Product Change Notification

Date Issued :	December 12, 2024	PCN Number :	515945
Reason for Change :	Change to Product		
Description of Change :	Adding air slots near the terminal exit of the housing to offer improved solder fill in excess of the industry standard defined by IPC-J-STD-001		
Assessment of Change :	No change to parts - Form/Fit/Function		
Planned Implementation Date :	June 30, 2025		
Customer Sample Availability Date:	December 20, 2024		
Last date to request Samples by Customer :	March 28, 2025		
Please note if Samples are not requested as per Customer Samples Request date, it may take additional 4-6 weeks to arrange Samples.			
Traceability Code Markings / Date :	Date code

Overview

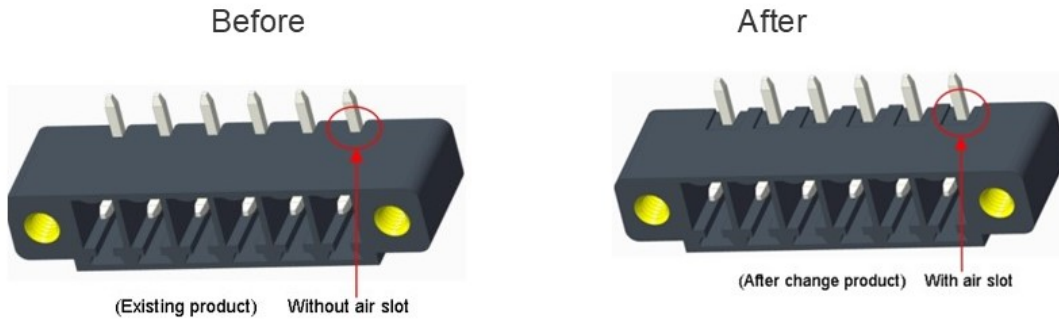
- A minor design change will be made to all series 39516 part numbers. The Change includes:
 - Adding air slots near the terminal exit of the housing to offer improved solder fill in excess of the industry standard defined by IPC-J-STD-001 (the international standard for solder processing).
 - Due to the existing design already meeting the solder standard, the implementation of the design change will be a "running change". This means there could be a mix of the existing and the new design in the product shipment.
 - The following is an illustration of the design change.
